SUBJECT: NuScale Power, LLC Response to NRC Request for Additional Information (RAI No. 9936) on the NuScale Topical Report, "Rod Ejection Accident Methodology," TR-0716-50350, Revision 2

REFERENCES: 1. NRC Letter Final Request for Additional Information (RAI) 9936, dated July 13, 2022, RAI# 9936
2. NuScale Topical Report Rod Ejection Accident Methodology, dated December 2021, TR-0716-50350, Revision 2

NRC Question No.: NTR-01

Licensing Topical Report

Figure 6-1 Power response at 55 percent power, end of cycle

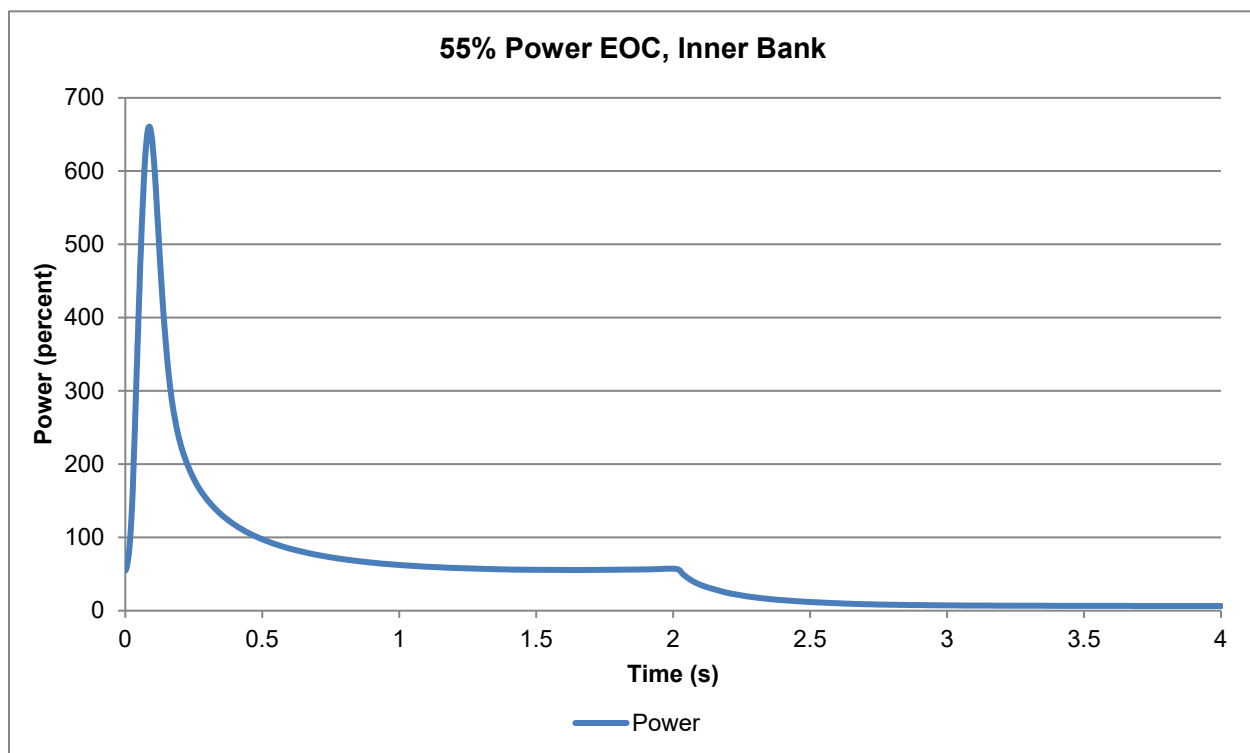
Section 5.1.2 of TR-0716-50350, Rev 2, states the REA is analyzed at BOC and EOC burnups to bound core reactivity conditions and the expected limiting MCHFR case will occur at EOC. Middle of cycle (MOC) conditions are not explicitly considered, and no justification is provided for the statement that EOC is limiting. Consistent with RG 1.236, the REA method should address the full spectrum of cycle burnup and range of power operation, which includes consideration of all MOC conditions.

To support a finding that the REA analysis is appropriately bounded, the staff requests that the TR be updated to include consideration of the full spectrum of cycle burnup and range of power operation in the set of initial conditions for the REA analysis, or provide justification for excluding MOC conditions from these initial conditions.

Figure 6-1 shows an example of the power response at 55 percent and EOC, which is the highest power case of an example core design and operational limits. The large CRA worth, which is effectively a prompt critical reactivity insertion, results in a rapid power increase. This power increase is quickly turned around by the negative MTC and DTC feedback. The reactor trip signal is given early in the transient, as soon as the two operating detectors show a 15 percent power increase, and a delay of two seconds is assumed. After the large, narrow pulse, with a pulse width at half height of 0.12 seconds, a nearly steady state power of around 56 percent is reached due to the uncertainty treatment until the CRAs start moving.
